CITY PLAN COMMISSION**THURSDAY, OCTOBER 10, 2024****FILE NUMBER:** S234-193**SENIOR PLANNER:** Sharmila Shrestha**LOCATION:** Empire Central, northeast of Harry Hines Boulevard**DATE FILED:** September 12, 2024**ZONING:** MF-2(A)**CITY COUNCIL DISTRICT:** 2**SIZE OF REQUEST:** 0.535-acres**APPLICANT/OWNER:** Kaminski Custom Builders

REQUEST: An application to create one 0.535-acre lot from a tract of land in City Block 2366 on property located on Empire Central, northeast of Harry Hines Boulevard.

EXISTING AREA ANALYSIS MAP

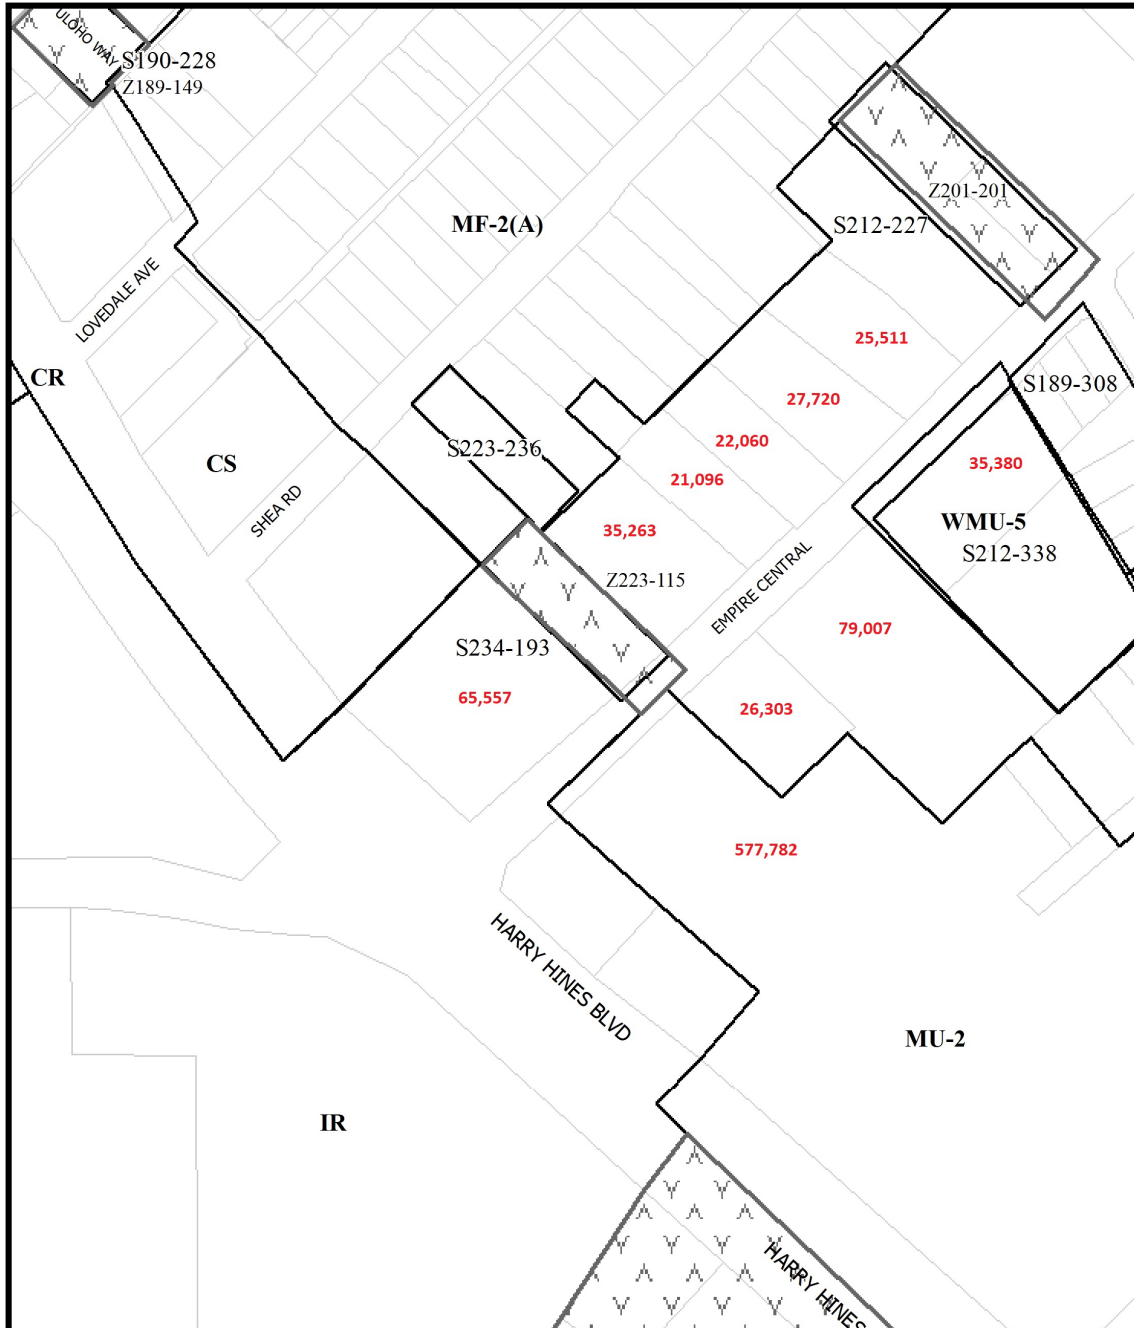
Staff finds that there is a variation in lot pattern within the immediate vicinity of the request. (*Refer to the existing area analysis map*). The request complies with the zoning requirement of the MF-2(A) Multifamily District and is in compliance with Section 51A-8.503; therefore, staff recommends approval subject to compliance with the following conditions:
